Fixing Late Model Ford Focus Engine Vibration Problems

Ford has issued a Tech Service Bulletin (TSB 11-3-24) regarding problems with engine vibration on the 2000-2011 Ford Focus. This article supersedes TSB 10-5-11 and applies to Anchor engine mount numbers 2938, 3003 and 3085.

Anchor # 2938, 3003 & 3085
(difference in part numbers
is the mounting hole location)

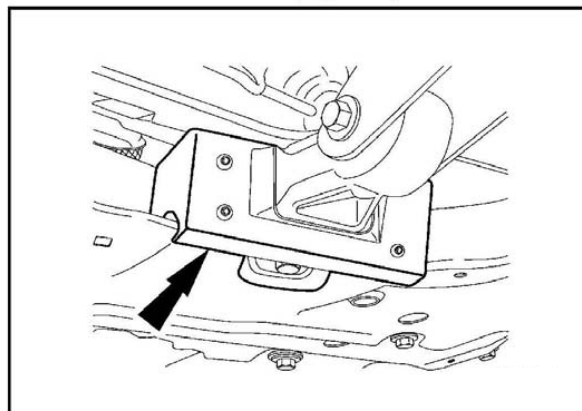
Some 2000-2011 Focus vehicles may exhibit an excessive engine vibration which is most noticeable when the transmission is engaged in reverse. This condition may be caused by small stones, road debris, ice or snow packed/lodged in the rear engine roll restrictor.

Inspect the rear engine roll restrictor for debris and install service shield.

1. Inspect the rear engine roll restrictor for debris.
2. Remove any debris from rear engine roll restrictor.
3. Remove the cross member-to-roll restrictor attachment bolt.
4. Install service shield. →
5. Install roll restrictor attachment bolt and torque to specification.
 - a. 2000-2007 model year vehicles - 47 N.m (35 lb-ft)
 - b. 2008-2011 model year vehicles - 70 N.m (52 lb-ft)
